Bulletin

HOLDEN

No. H96-G

EXCESSIVE OIL CONSUMPTION VALVE ROCKER SHAFT OIL CONNECTOR — REWORK

Fig. 1

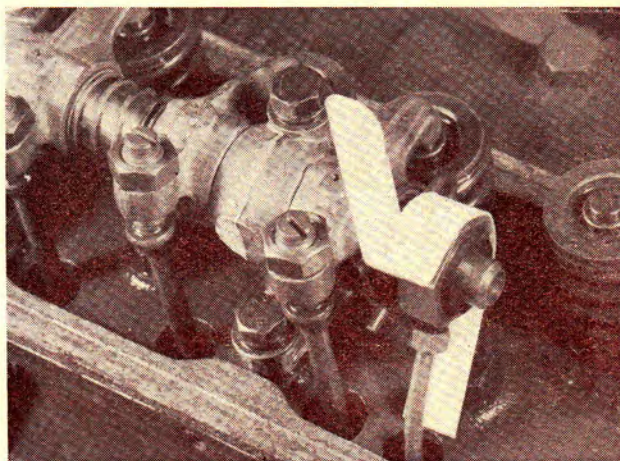
Note: With the increased size of oil connector relief hole, excessive splash and oil loss may take place whilst adjusting the valve clearance unless some sort of deflector is used. A simple type of deflector can easily be fabricated from light gauge sheet metal $\frac{3}{8}$ in. wide x 6 in. long, shaped so that it can be readily hooked on to the oil connector and will deflect the oil from the connector relief

hole into the centre drain back hole in the cylinder head, Fig. 1. The extended end of the deflector is to prevent the rocker cover being inadvertently replaced with the deflector in position.

On all vehicles after Engine No. 197344 which are reported to be using excessive oil, it is recommended that the oil flow to the overhead gear be reduced by increasing the size of the oil relief (over-flow) hole in the oil connector to $\frac{1}{8}$ in. MAXIMUM. This modification should always be carried out and the vehicle re-tested for oil consumption before any major overhaul is attempted.
